# St. Lucie Unit 2

## NRC Update SL2-13 November 2001 Steam Generator Inspection Plans

STEAM GENERATOR TUBE INSPECTION DISCUSSION POINTS  
 PREPARED BY THE OFFICE OF NUCLEAR REACTOR REGULATION  
 FLORIDA POWER AND LIGHT COMPANY  
 ST. LUCIE PLANT, UNIT 2  
 DOCKET NO. 50-389

STEAM GENERATOR TUBE INSPECTION DISCUSSION POINTS  
PREPARED BY THE OFFICE OF NUCLEAR REACTOR REGULATION  
FLORIDA POWER AND LIGHT COMPANY  
ST. LUCIE PLANT, UNIT 2  
DOCKET NO. 50-389

9

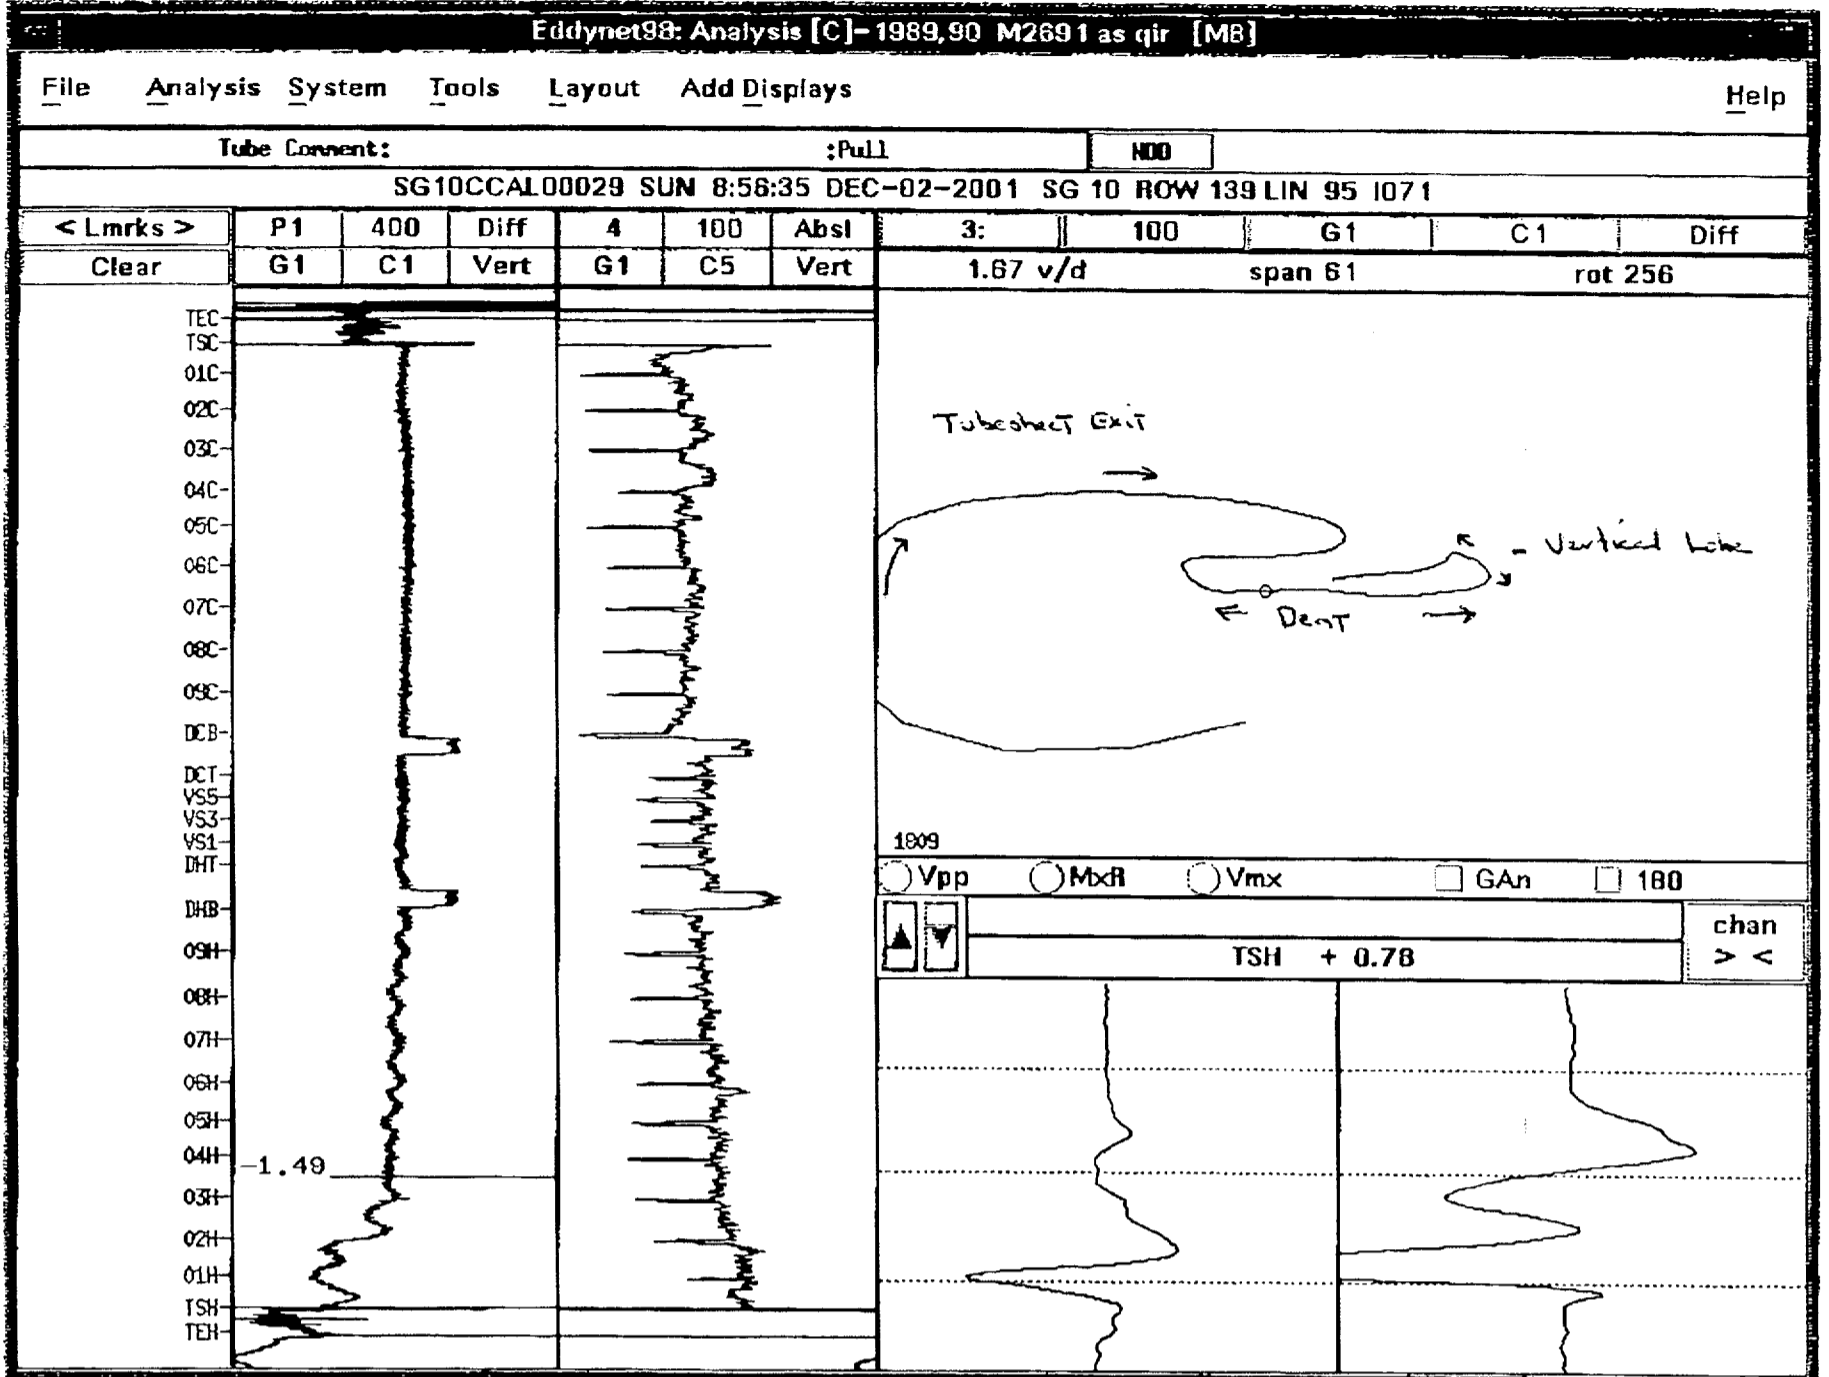
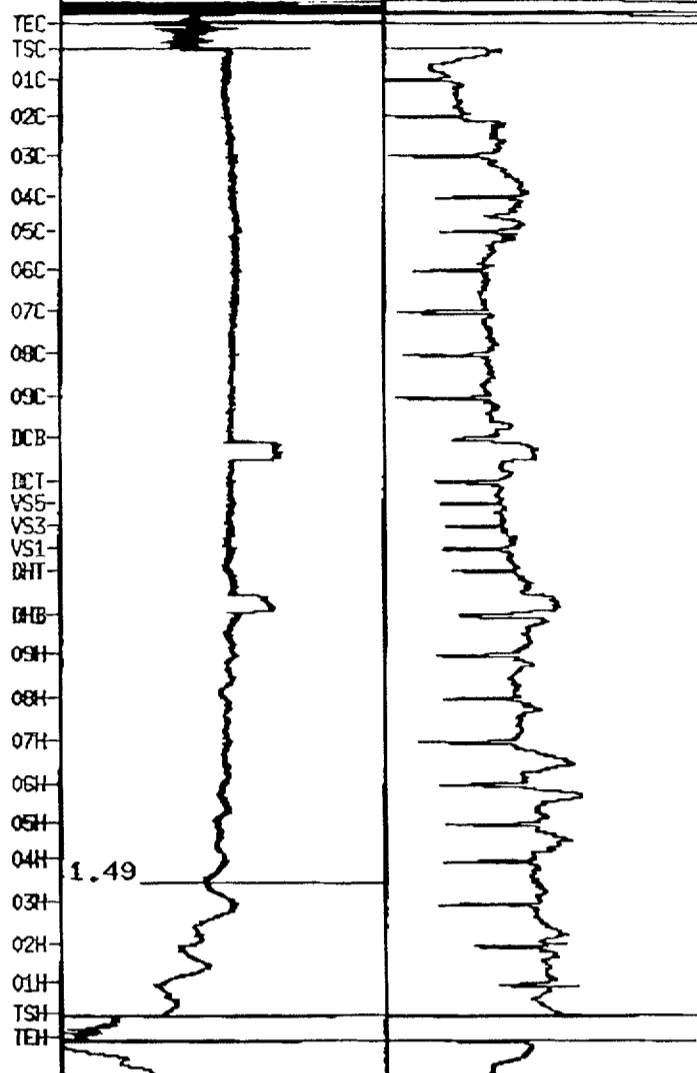
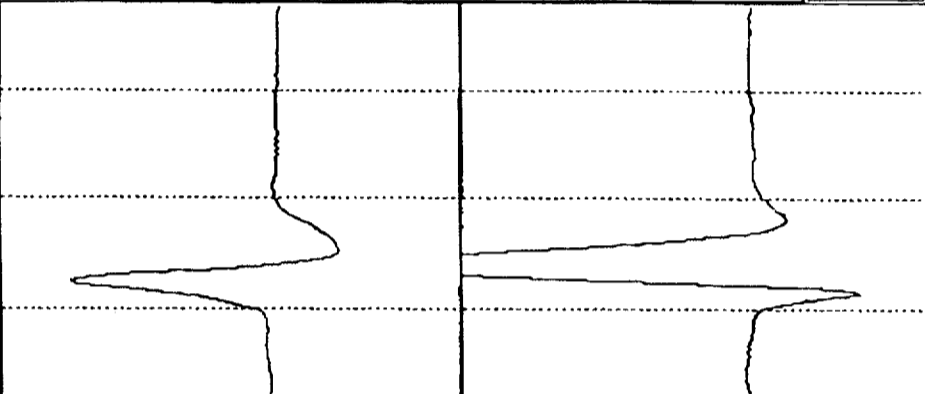
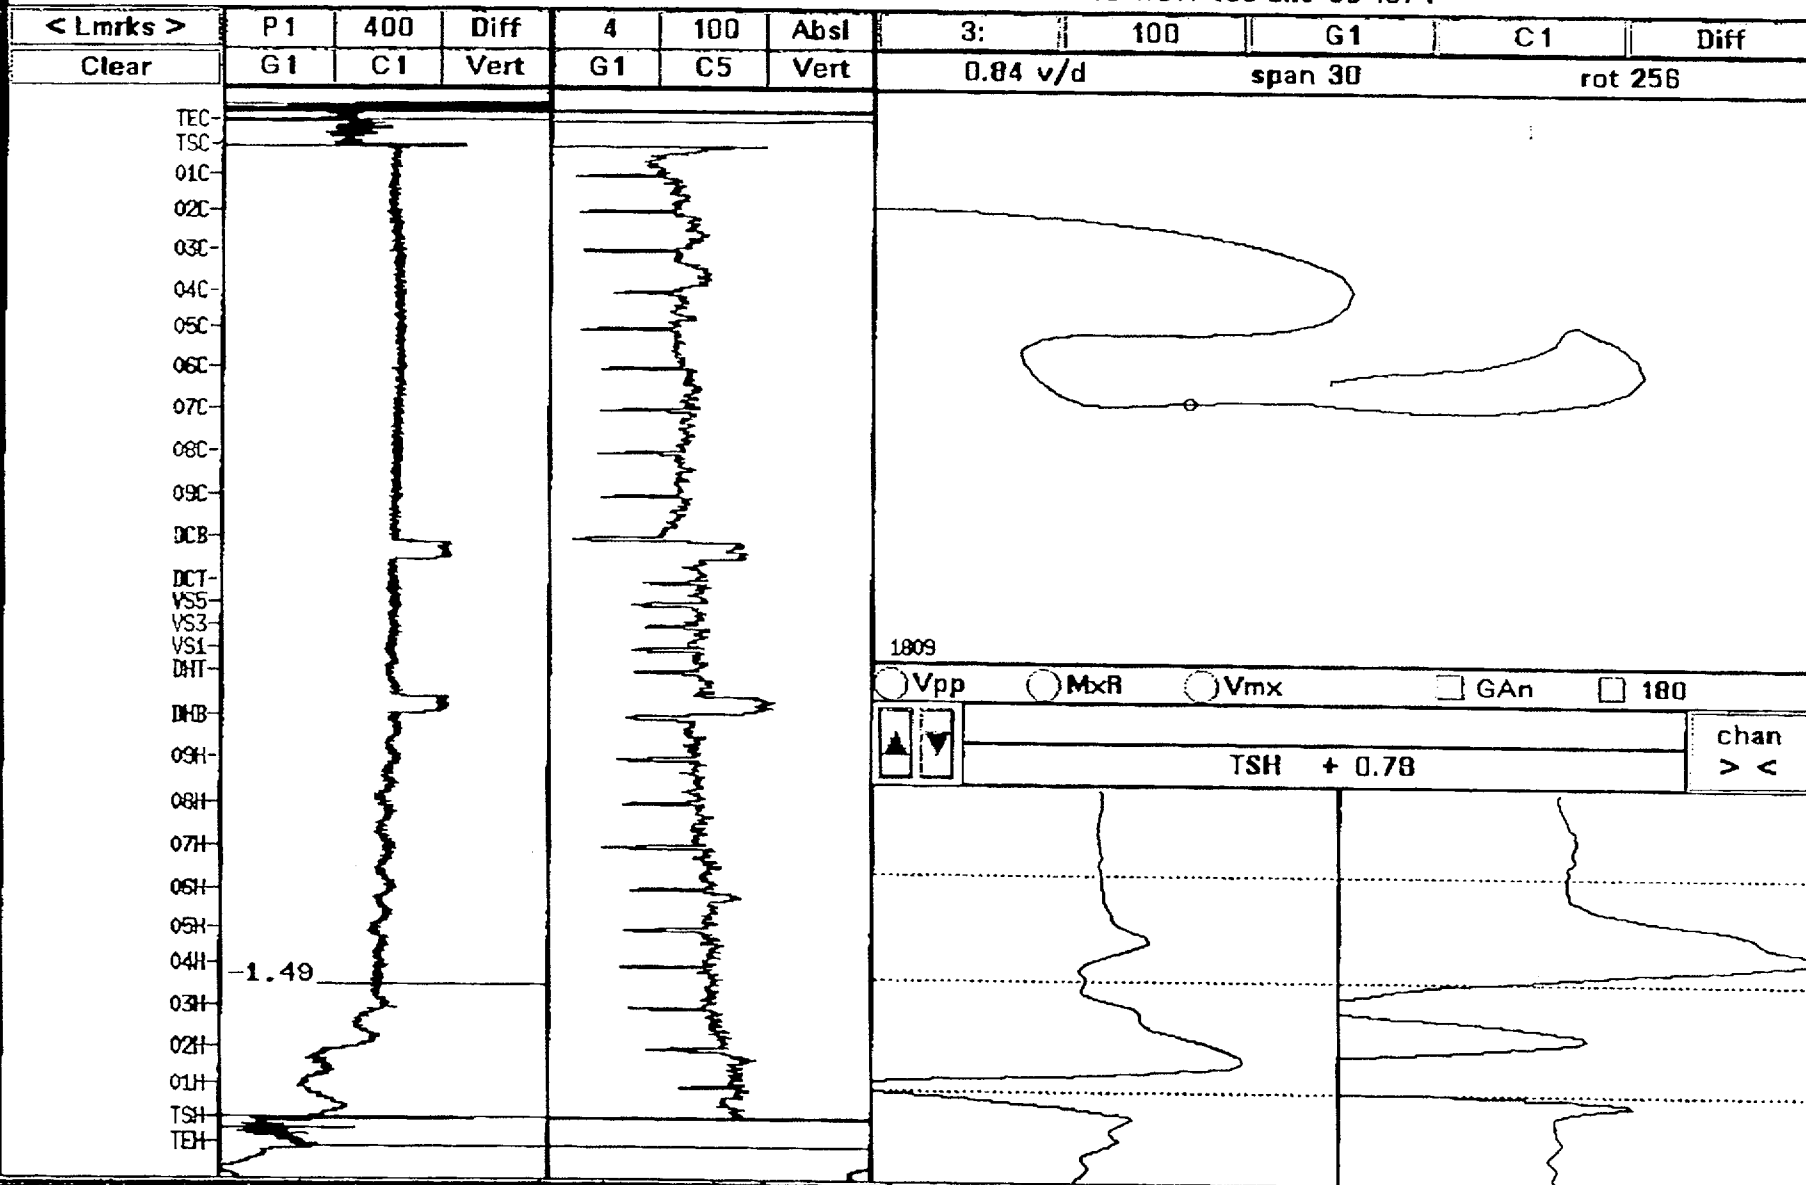
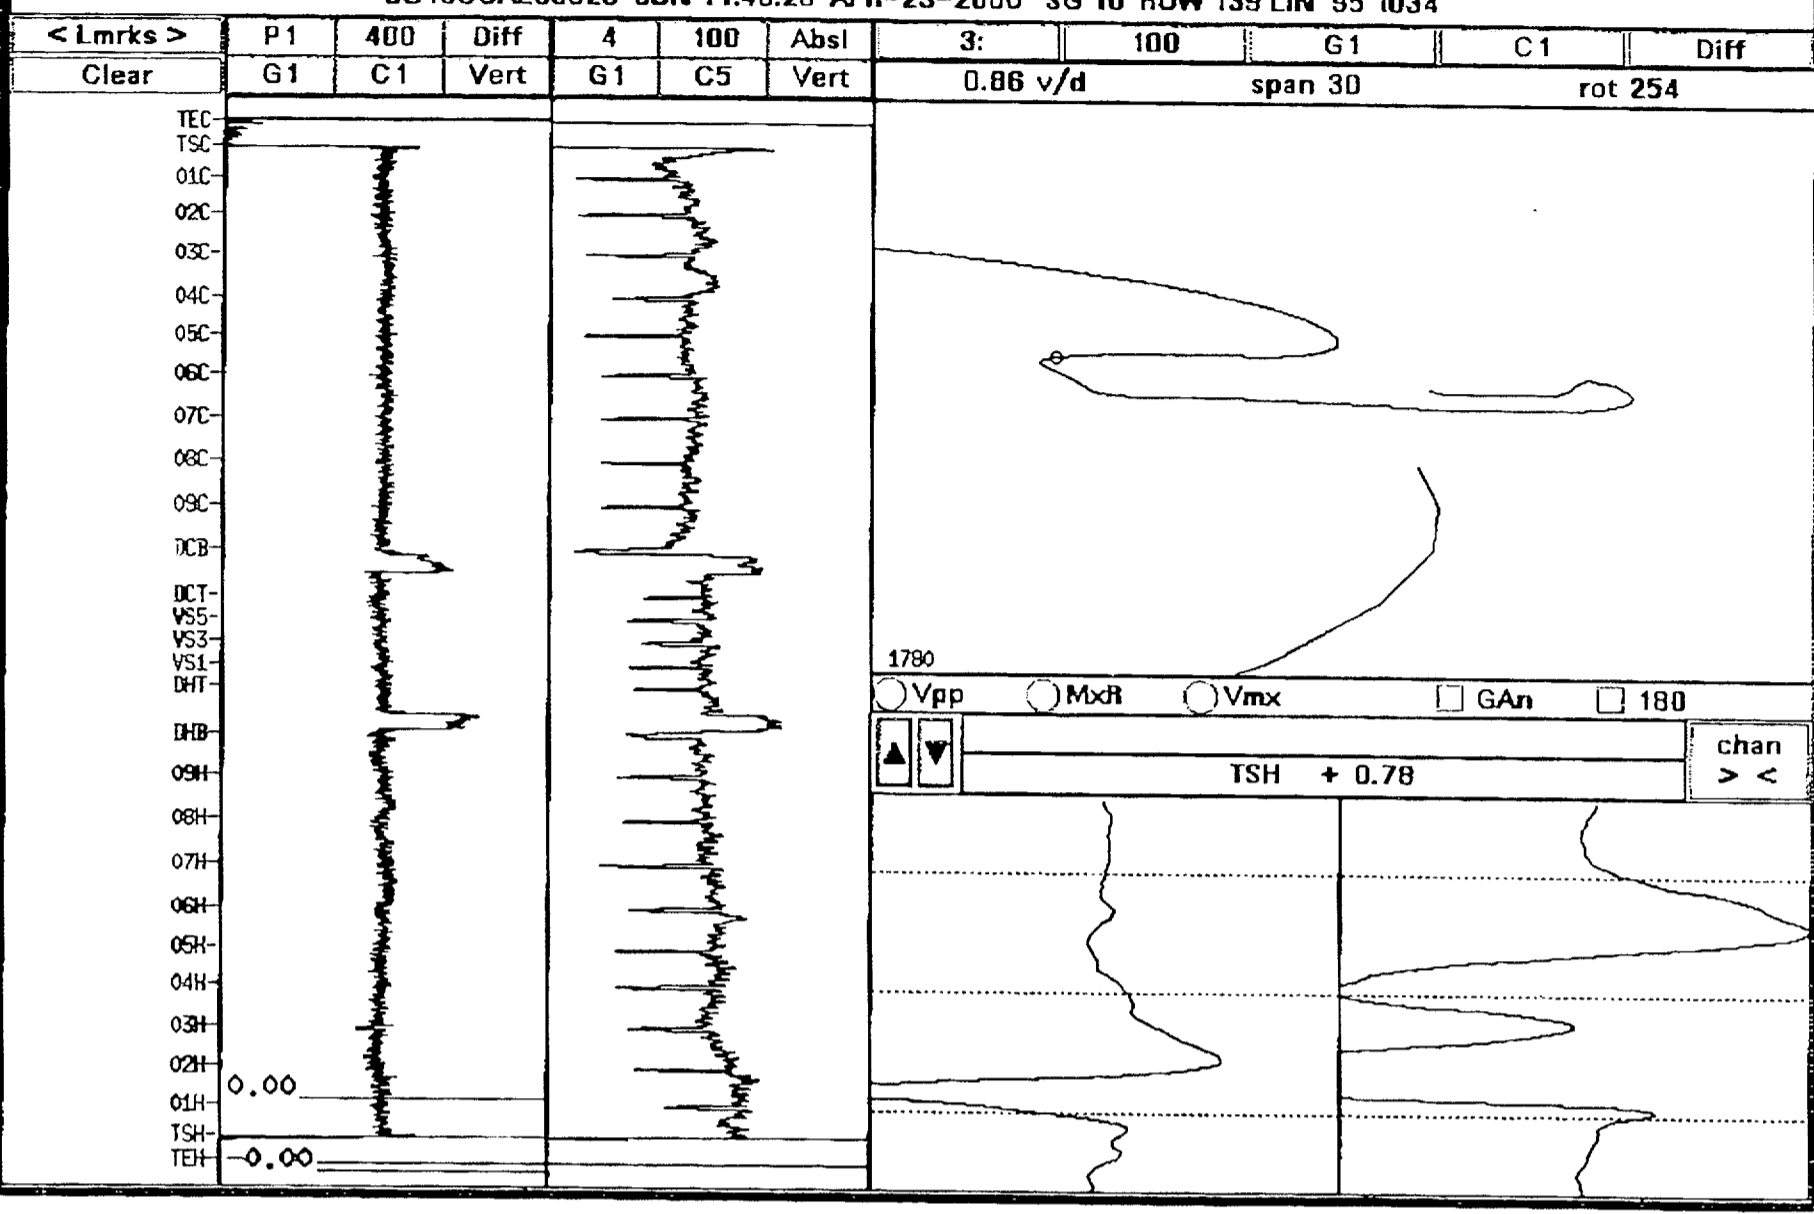
**Issue 1:** Provide eddy current graphics and discuss the evolution of the worst indications detected in dents (See Attachment 1 – 13 Pages).
